Document Modification Request

25 DMR No
96-DMR-ERM-0041

1 Name/Phone/Pager/Location Edward C Mast x5757, dp 4672, Bldg T893A, FAX 2623			2 Date Aug 21, 1996		
3 Existing Document Number and Revision RF/ER-96-0041 Rev 0 Sampling & Analysis Plan			4 Document Type <input type="checkbox"/> Procedure <input type="checkbox"/> Plan <input type="checkbox"/> Other		
5 Document Title Sampling and Analysis Plan for the Pre-Remediation Investigation of the Mound, 903 Pad and T1-Trench

Document Modification Request for the Sampling and Analysis Plan for the Pre-Remediation Investigation of the Mound, 903 Pad and Trench T-1 RF/ER-96-0041 Un, Rev 0

Mound Soil Gas

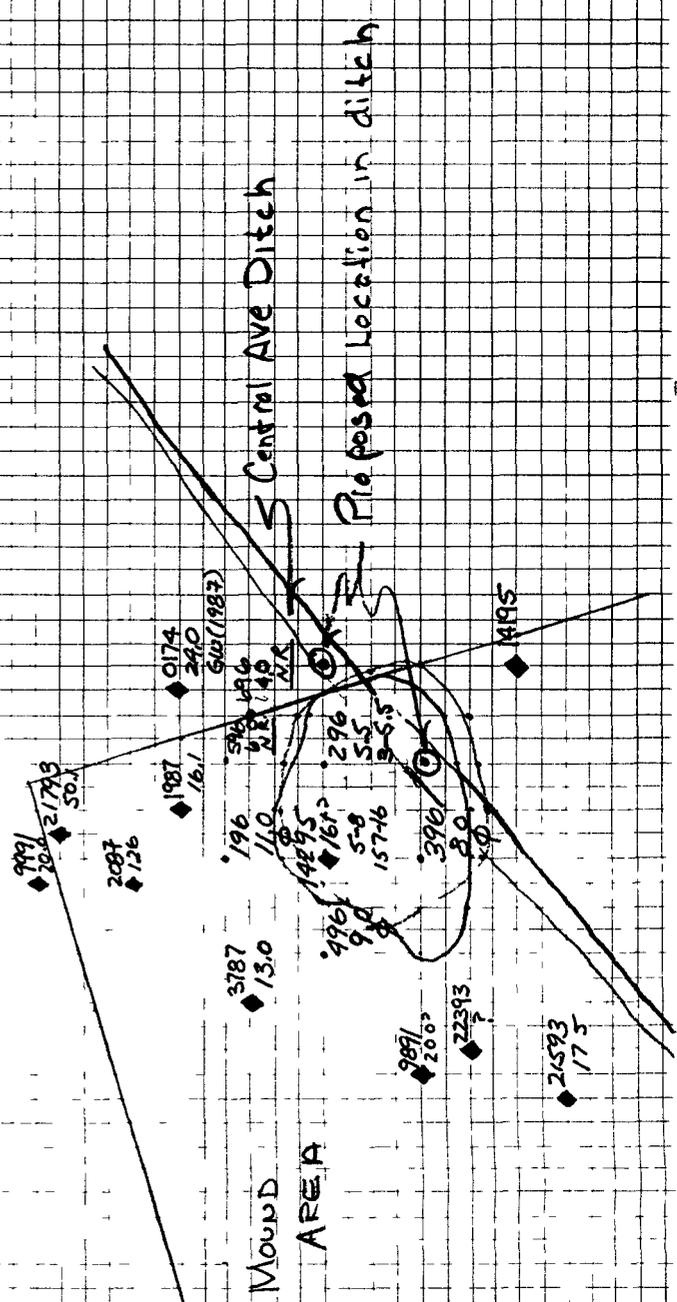
6 Item	7 Page	8 Step	9 Proposed Modification
			<p>Revision of boring locations, based on inability to penetrate through the alluvium with the geoprobe See attached modification and sketch map</p>

The intent of the soil borings in the Mound Area was to penetrate through the alluvium into unweathered bedrock which was projected to be 15 to 20 feet BGS. However, adverse field conditions, tight clays and large cobbles, have prohibited the collection of soil samples at depths greater than 11 feet in the first nine borings completed. Because of the inability to completely penetrate the alluvium with the geoprobe, the potential pathway for contamination can not be fully established. To further establish this pathway, a series of boring downgradient from the Mound Area and between the Mound Area and contaminated well at SW59 will be completed. All but two of the remaining proposed boring locations will be reprogrammed. The two exceptions are the borings that are located in the Central Avenue Ditch. These two boring will be completed when the ditch dries out

The remaining borings will be located in a "fence line" north of the Mound Area within 20 feet and south of the subcrop of the alluvial/bedrock contact. The alluvial/bedrock subcrop contact can be identified in the field by a observable change in slope between the more resistant alluvium versus the less resistant claystones of the bedrock.

The borings will be spaced approximately 10 feet apart and the initial location will be north of BH14295 with the exact location at the discretion of the project geologist. The depth of these borings is expected to be 10 to 15 feet but will, when possible, be completed into unweathered bedrock (see attached sketch map)
